Supplement to 8/17/2020 MPWMD Board Packet

Re: Marina Coast Water District's Comments on Resolution No. 2020-13
(Exhibit 1-B) adopting the Construction of a Bypass Pipeline Modification
Addendum as Addendum 6 to the ASR EIR/EA.

RE: Proposed Bypass Pipeline and De-Chlorination Facility Modification

ATTACHMENT 1

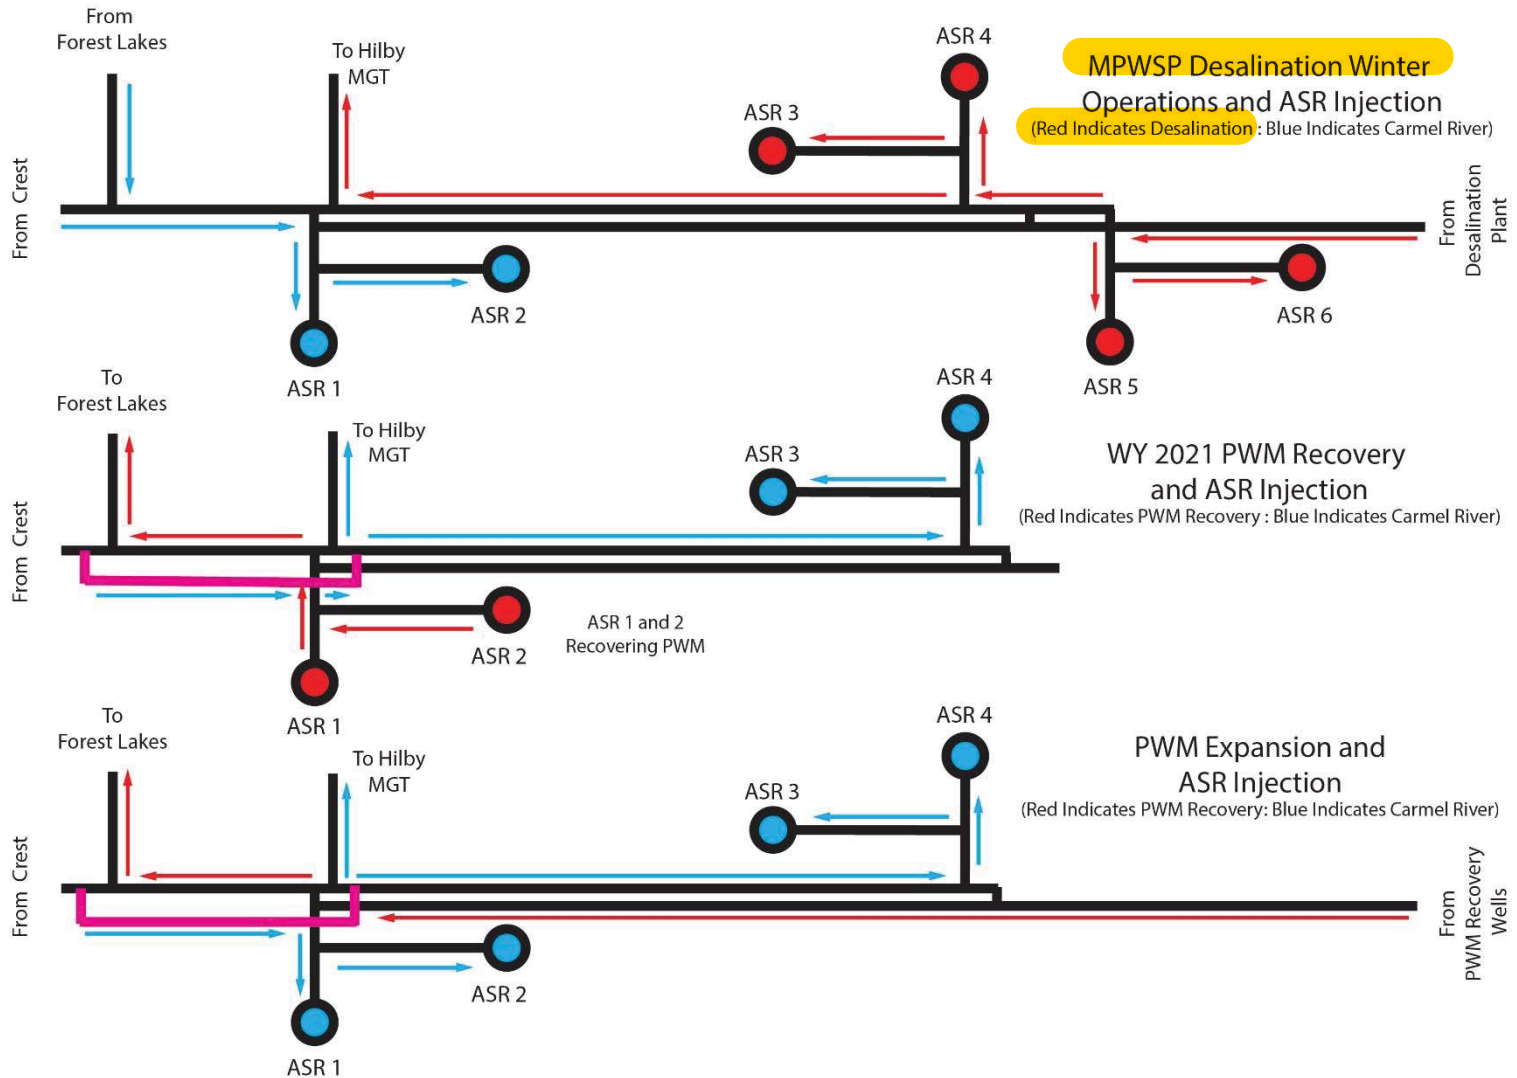
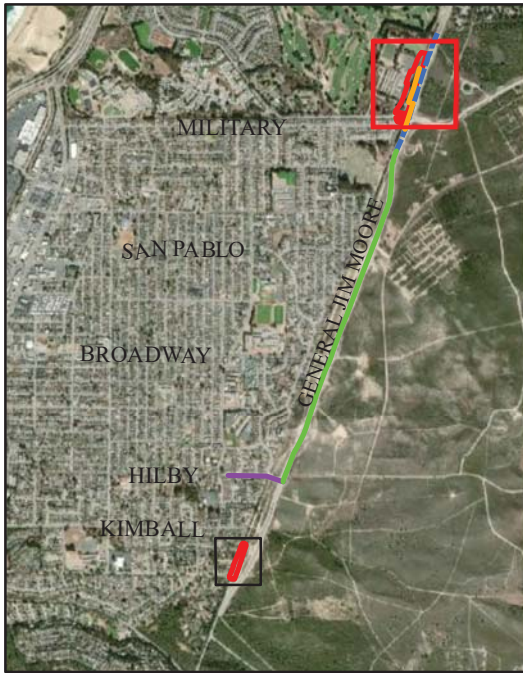
As explained in more detail below, the July 20 MPWMD Staff Presentation and Addendum reveal that the proposed bypass pipeline would connect with Cal-Am's currently useless desalination plant pipeline and that the bypass pipeline is designed and sized for the purpose of carrying "desalination" plant water – not ASR water. (See Attachments 1 and 2). Addendum No. 6 also appears to show the new pipeline would connect or interface with MCWD's potable water pipeline in General Jim Moore Blvd., which raises multiple logistical and environmental concerns that are not addressed in the Addendum or other communications with MCWD. Therefore, MCWD requests the Board delay consideration of Addendum No. 6 to allow your staff time to meaningfully consult with MCWD on these issues and those discussed below.

MCWD is concerned about drawings in Addendum No. 6 documents and the staff presentation that clearly show the proposed Bypass Pipeline Project (Project) is intended to be an extension of CalAm's desalination pipeline for CalAm's desalination project. We absolutely oppose the location of the intake wells on the CEMEX property and CalAm's desal project unless and until, at minimum, the intake wells for the desal project are moved to north of the Salinas River.

Figure
1a

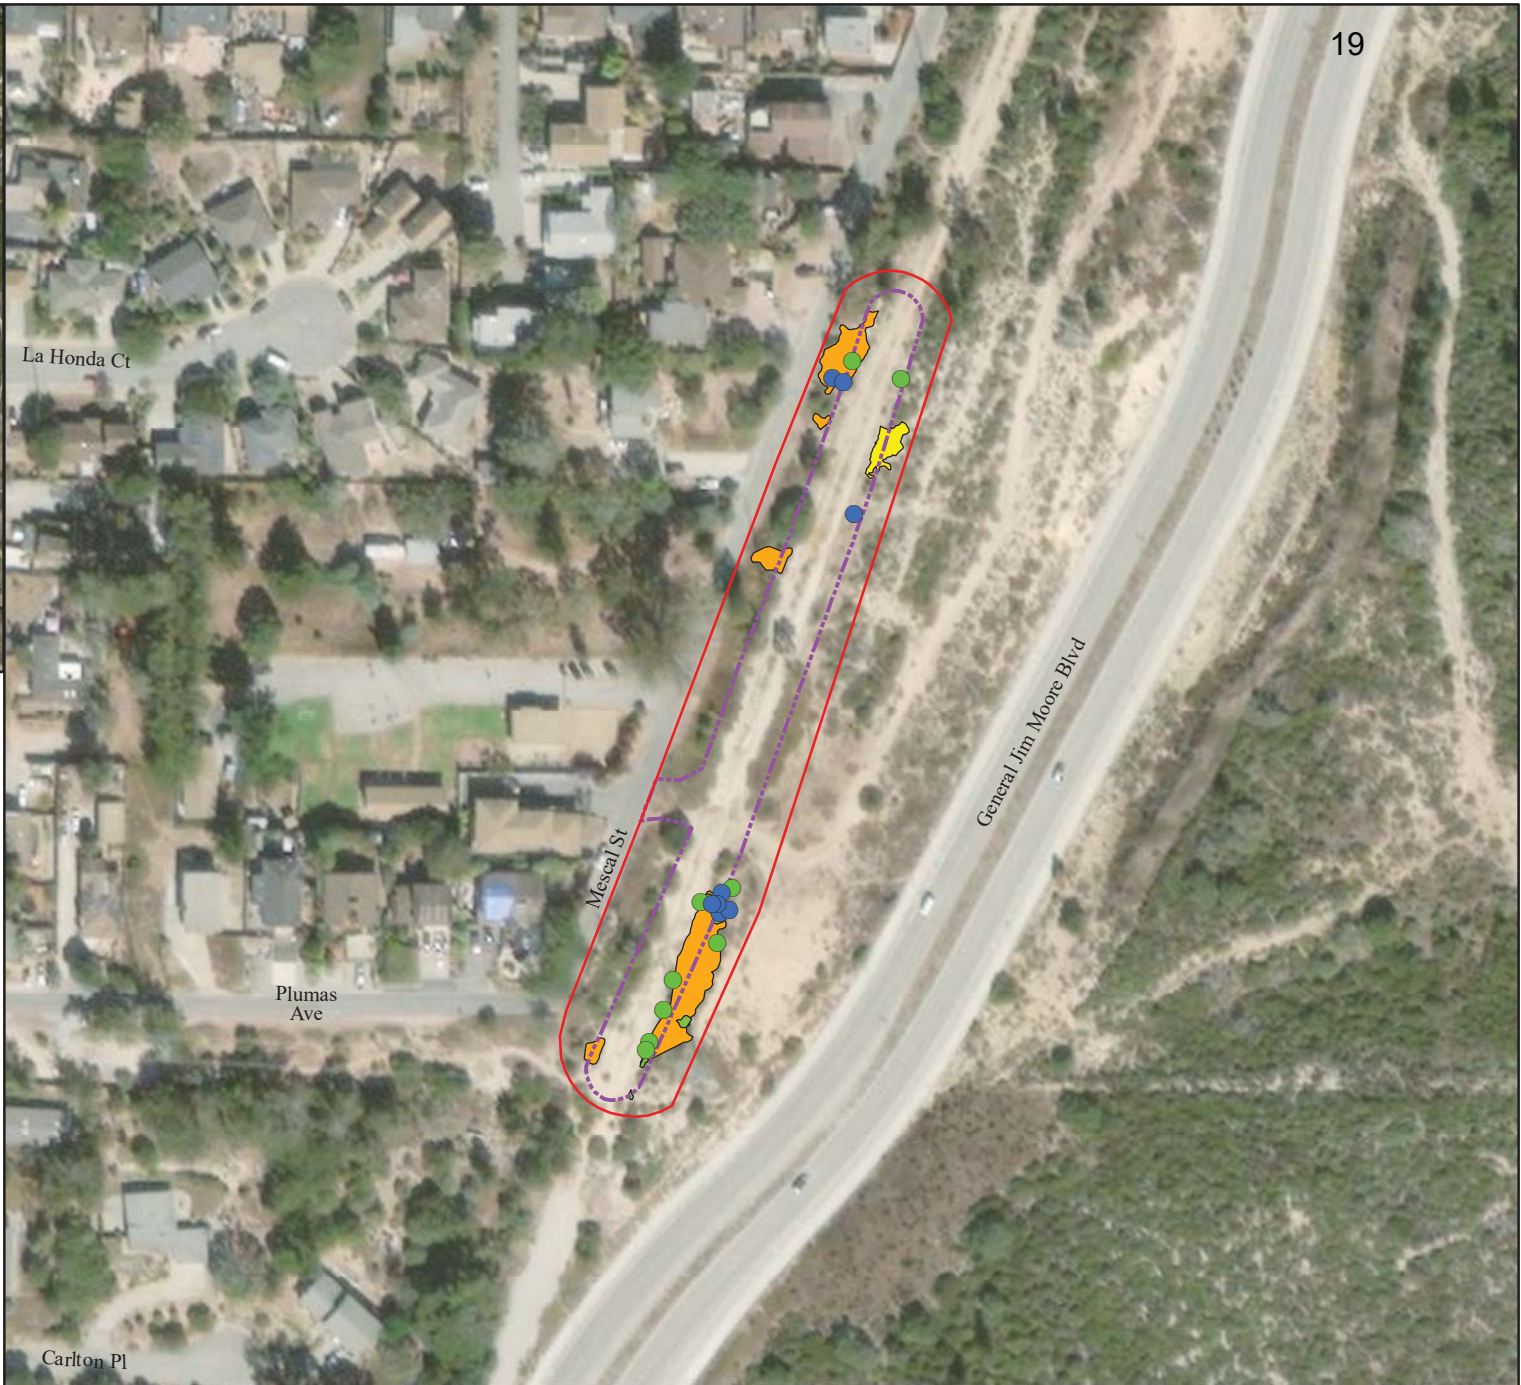
The Addendum has additional flaws that must be corrected before the project can be approved. First, the Addendum seems to rely on mitigation measures to reduce numerous impacts, but it is not always clear what mitigation measures will apply or how they will be effective. For example, the discussion of biological impacts seems to rely on surveys and other mitigation to reduce impacts, but it is not clear from the analysis what mitigation measures apply. It is not sufficient to simply state that the mitigation measures in the EIR will apply. If the Addendum is relying on mitigation measures from other documents (either the EIR or a prior addendum) to reduce impacts, the measures must be clearly identified in the Addendum and the Addendum must explain how those measures will be effective at reducing impacts.
